# Service Bulletin

Bulletin No.: PI0590A

**Subject:** Headliner Assembly Loose/Sagging at Rear of Sunroof Opening

**Models:** 2011-2012 Buick Regal  
Equipped with Sunroof (RPO CF5)

2717494

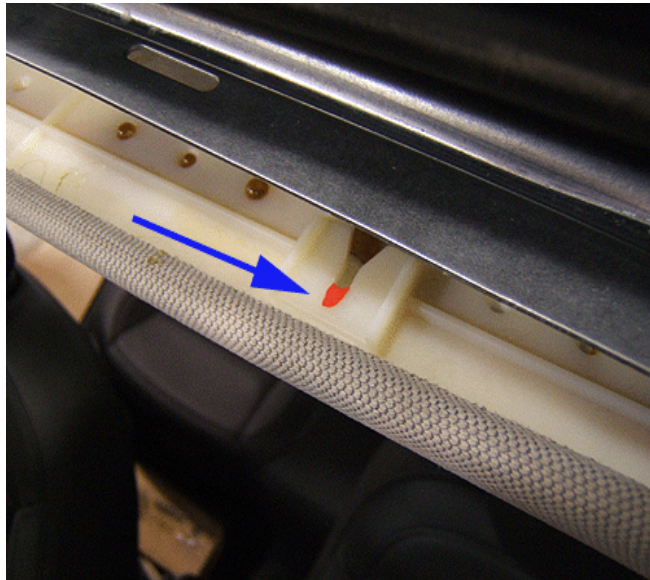
1. Remove the three hook and loop fasteners from the headliner assembly at the rear of the sunroof opening. Slide the fasteners out of the attachment slots in the headliner assembly.

2717500

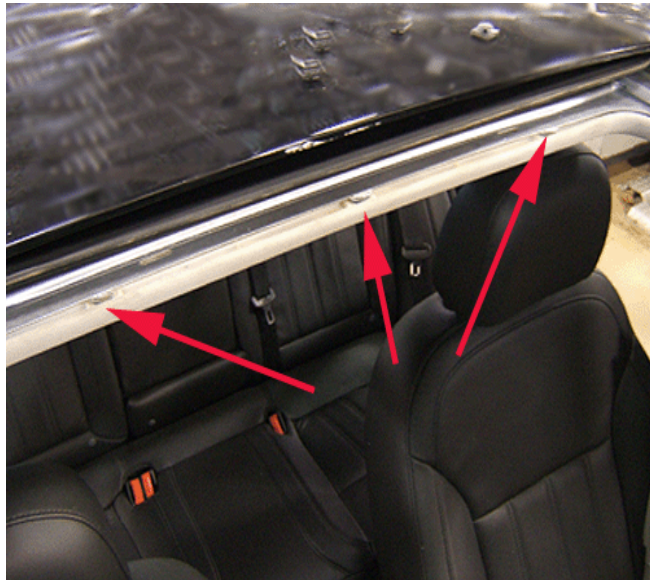
5. Use a small file or rotary bit on a die grinder to lengthen the attachment slots as shown. Use care to prevent over cutting the material.
